## **Appendix I – Modifications of Standards at SGH**

**From:** [Seth Timmerman](#)  
**To:** [Snyder, Chris](#); [Strack, Paul](#); [Muia, Maria](#); [Tom Franzen](#)  
**Subject:** Fwd: SGH Proposed MOS for Runway 15/33 OFA  
**Date:** Friday, January 31, 2020 3:41:57 PM

**From:** **Delaney, Katherine S (FAA)** <[Katherine.S.Delaney@faa.gov](mailto:Katherine.S.Delaney@faa.gov)>  
**Date:** Fri, Jan 31, 2020 at 3:38 PM  
**Subject:** SGH Proposed MOS for Runway 15/33 OFA  
**To:** Seth Timmerman <[stimmerman@springfieldohio.gov](mailto:stimmerman@springfieldohio.gov)>  
**Cc:** Erskine, Alex (FAA) <[Alex.Erskine@faa.gov](mailto:Alex.Erskine@faa.gov)>

**CROSSWIND RUNWAY 15-33 ALTERNATIVES  
 ALT. C-5 REQUEST FOR MODIFICATION TO STANDARDS  
 SPRINGFIELD-BECKLEY AIRPORT  
 SPRINGFIELD, OHIO**

**CROSSWIND RUNWAY 15-33 ALTERNATIVES**  
**ALT. C-7 SHIFT RUNWAY 75' NORTHWEST**  
**SPRINGFIELD-BECKLEY AIRPORT**  
**SPRINGFIELD, OHIO**

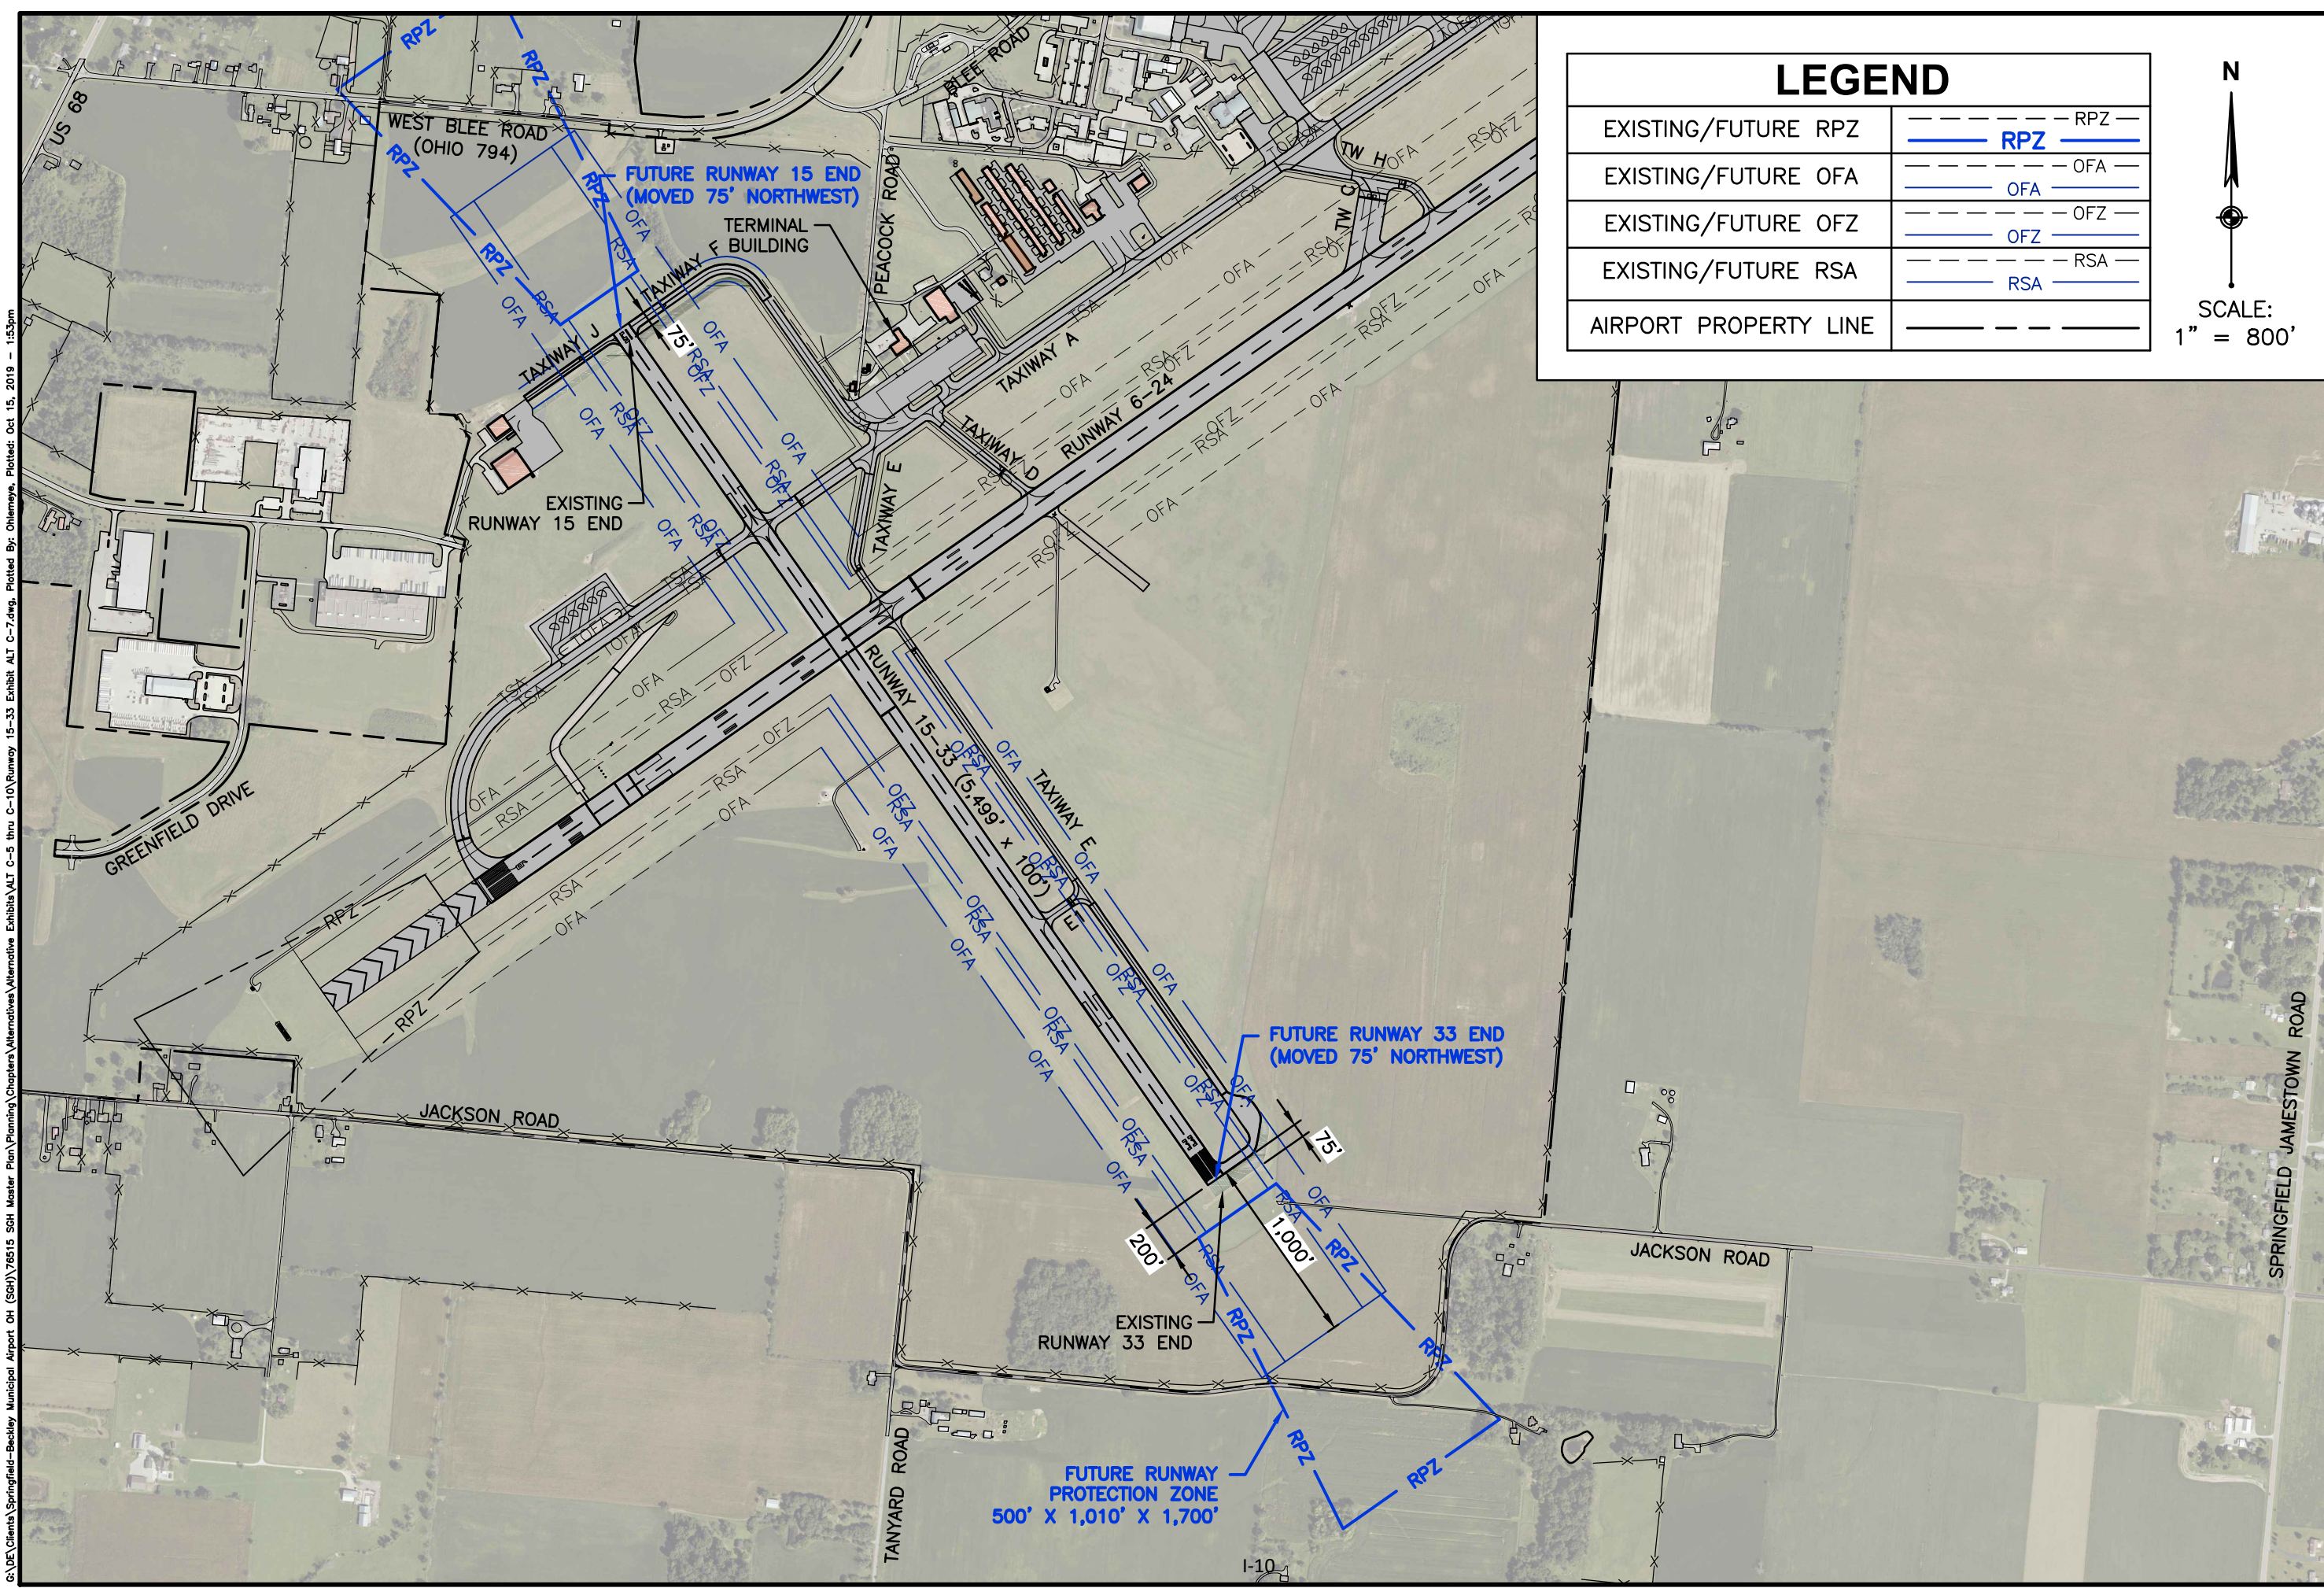
Alternative C-7: Shift Runway 15-33 75 feet to the north to clear the Runway 33 ROFA (see *attachment Runway 15-33 Exhibit Alt C-7.pdf*. This option requires reconstructing Taxiways J and F and the connector off the south end of Taxiway E (all 75 feet northwest of their present location). It requires adding 65 feet of pavement to the end of Runway 15 and removing 75 feet of pavement from Runway 33. The associated runway and taxiway marking and lighting would also have to be shifted and or removed.

**CROSSWIND RUNWAY 15-33 ALTERNATIVES**  
**ALT. C-8 DECLARED DISTANCE TO FIX RW 33 ROFA ONLY**  
**SPRINGFIELD-BECKLEY AIRPORT**  
**SPRINGFIELD, OHIO**

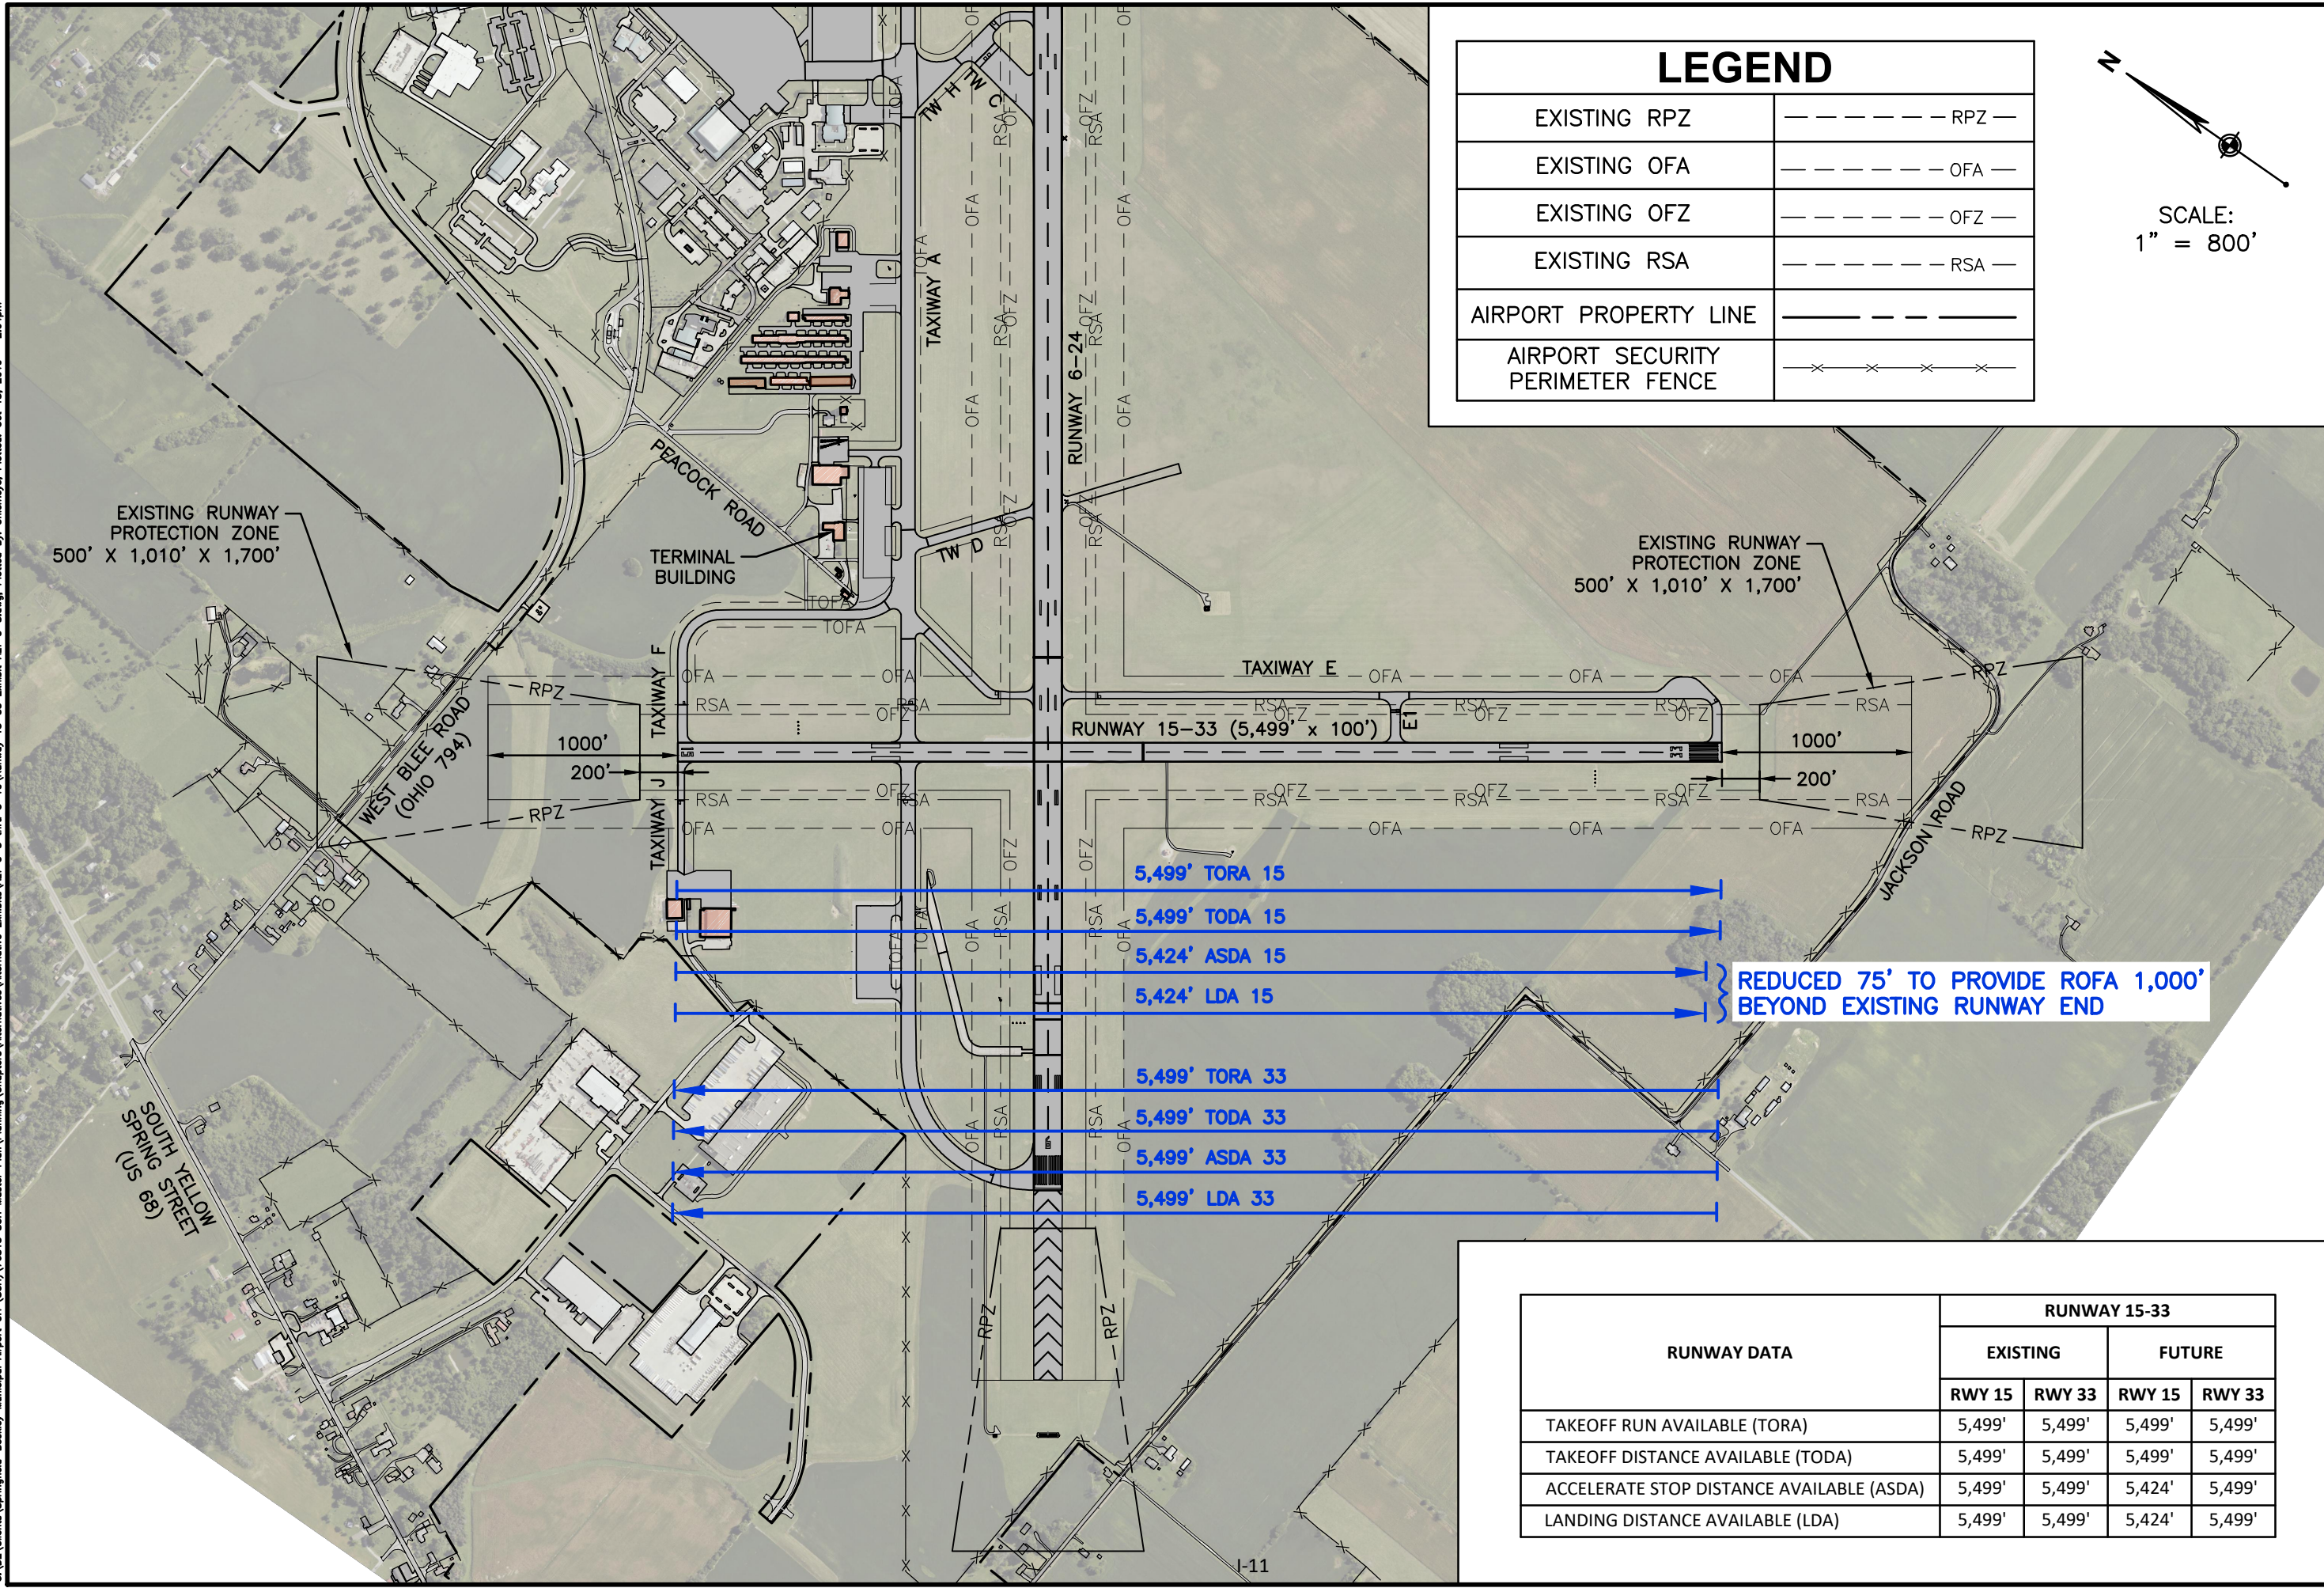
Alternative C-8/: Declared Distance to fix Runway 15 ROFA (see *attachment Runway 15-33 Exhibit Alt C-8.pdf*). This reduces the ASDA and LDA for Runway 15 by 75 feet. It provides a clear ROFA for Runway 33, but not a compatible RPZ. The RPZ for Runway 15 remains incompatible as it is today.
